CITY OF PORTLAND, MAINE
PLANNING BOARD

**RE: 606 and 616 Forest Avenue. Walgreens Pharmacy
Application # 2007-0188**

**RE: 606 and 616 Forest Avenue. Walgreens Pharmacy
Amendments to approved site plan - Loading
Application # 2007-0188**

**RE: 606 and 616 Forest Avenue. Walgreens Pharmacy
Modifications to approved exterior lighting plan
Application # 2007-0188**

DRAWING NO. **C1.1**

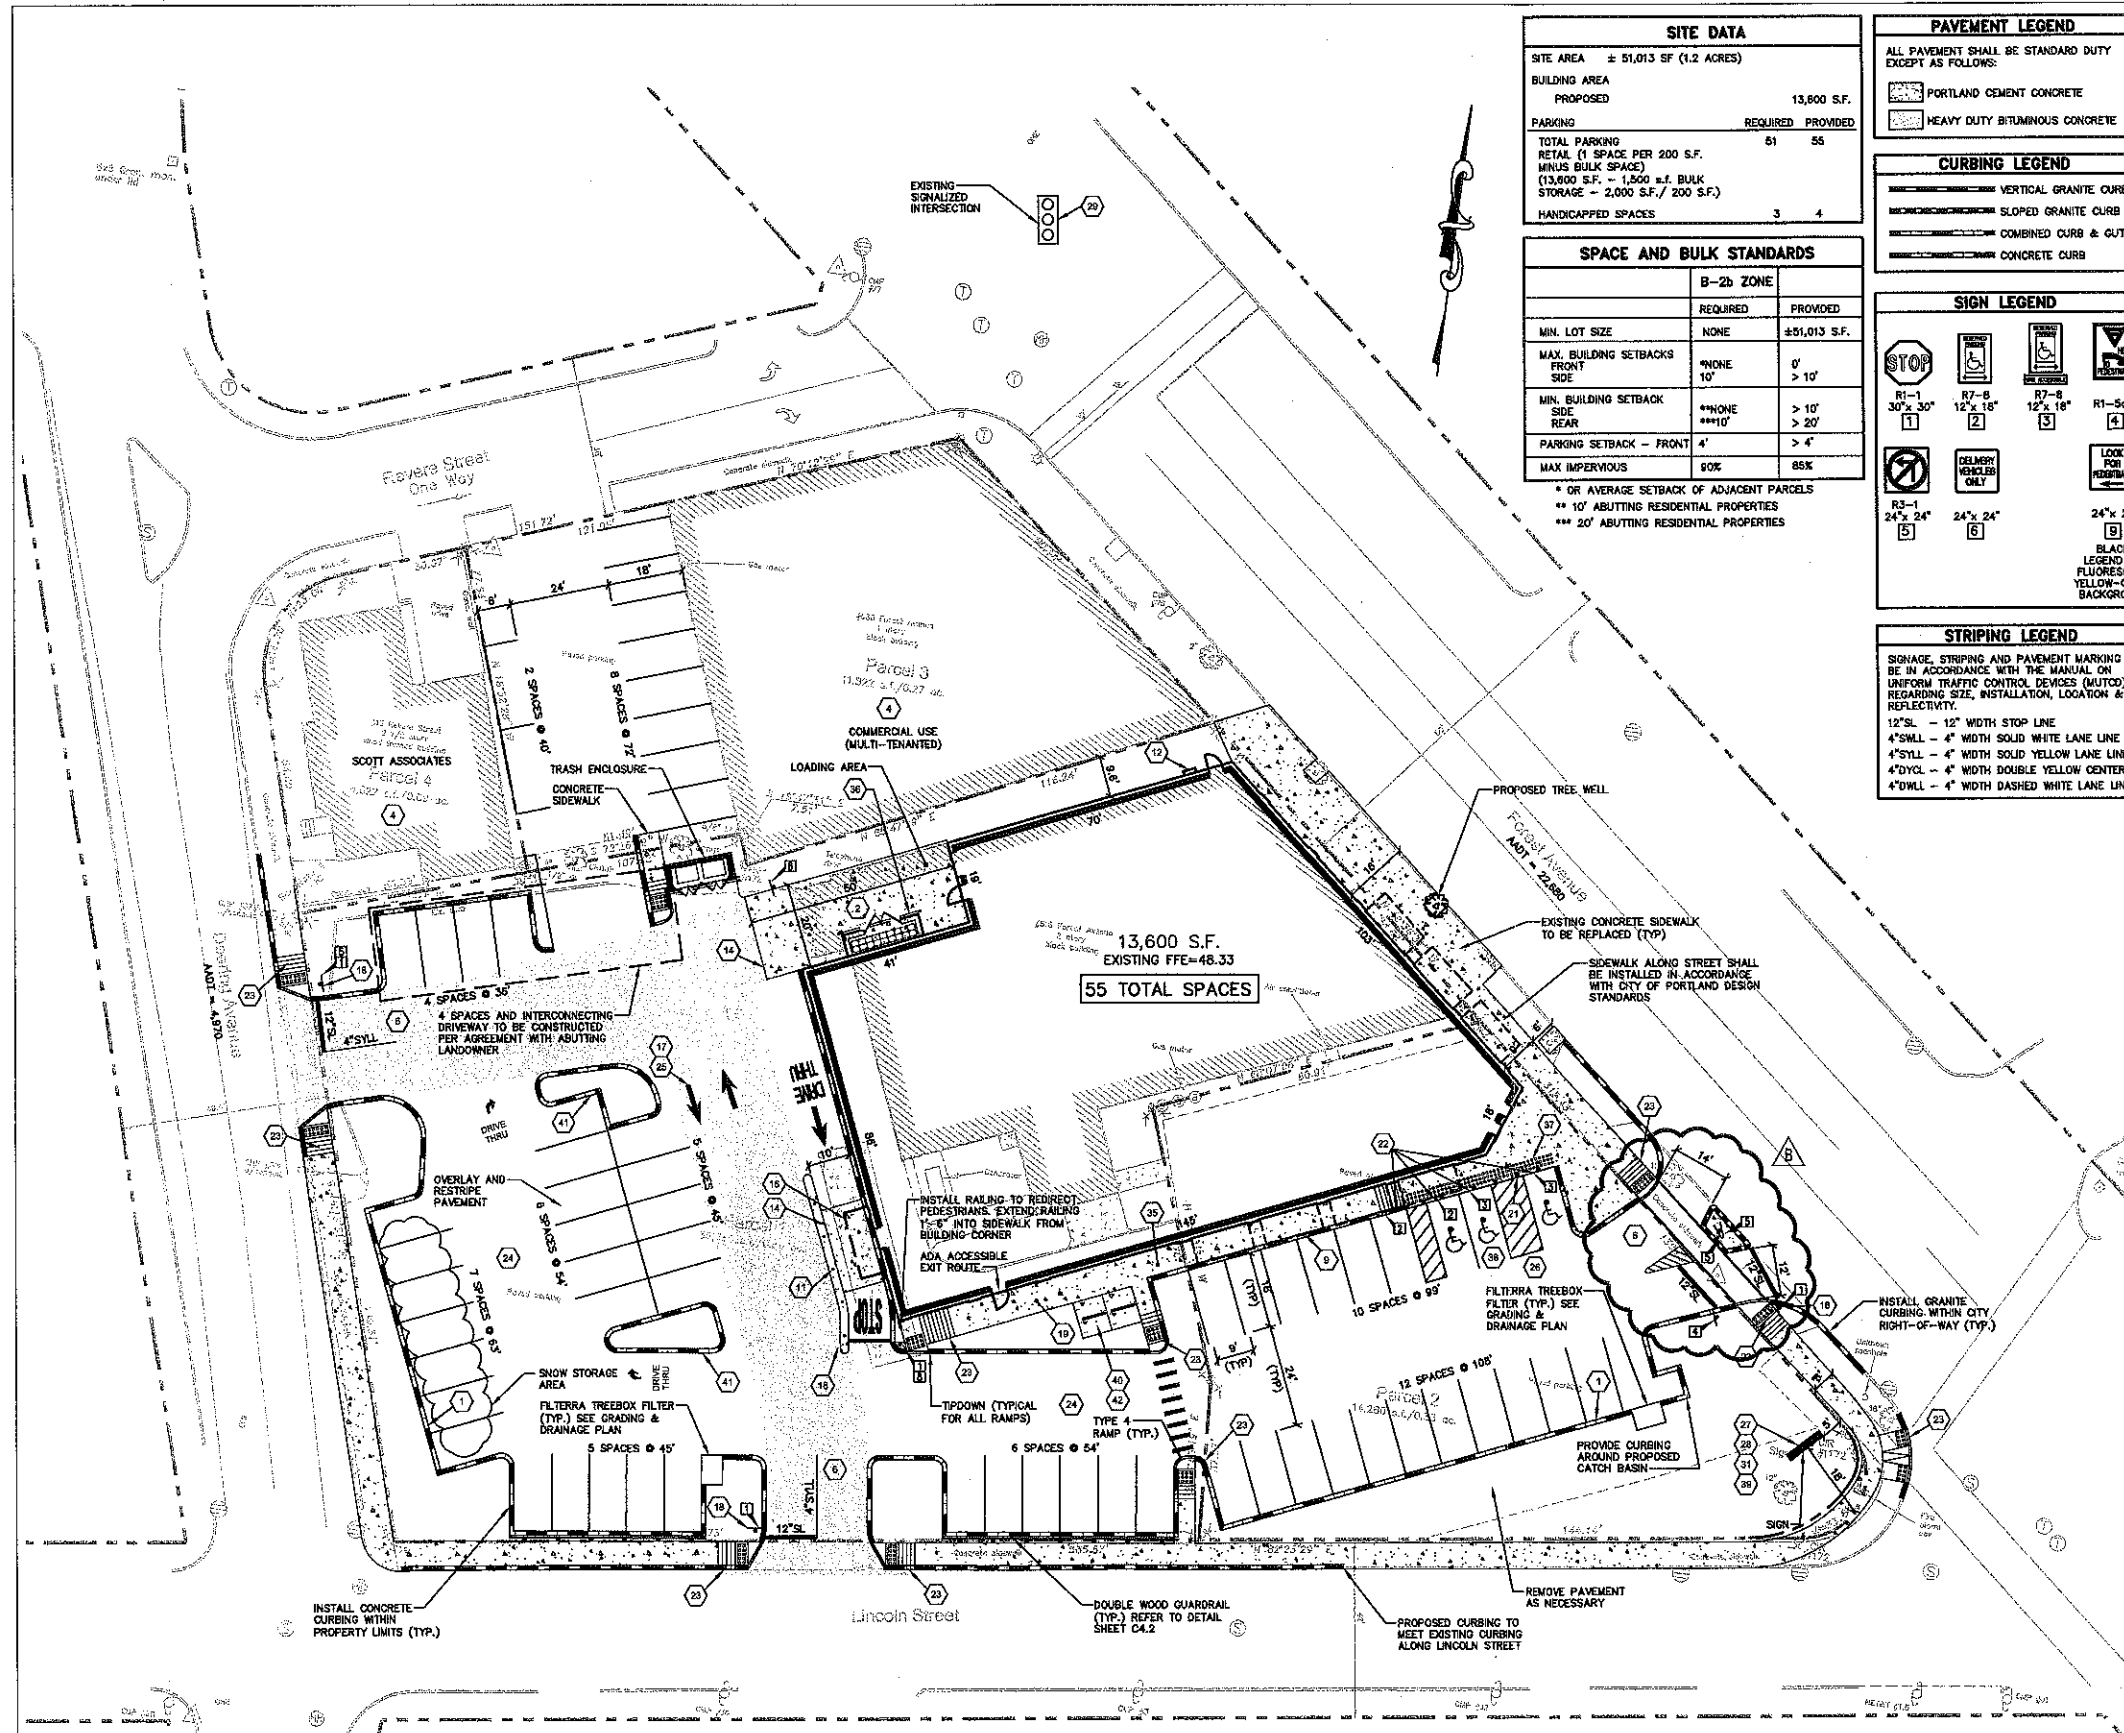
Comment 5 – The notes on sheet C1.1 references sheet C4.2 for truck turning radius information. It is assumed that the reference should be for sheet C4.6.

Response – The plans have been revised to reference sheet C4.6.
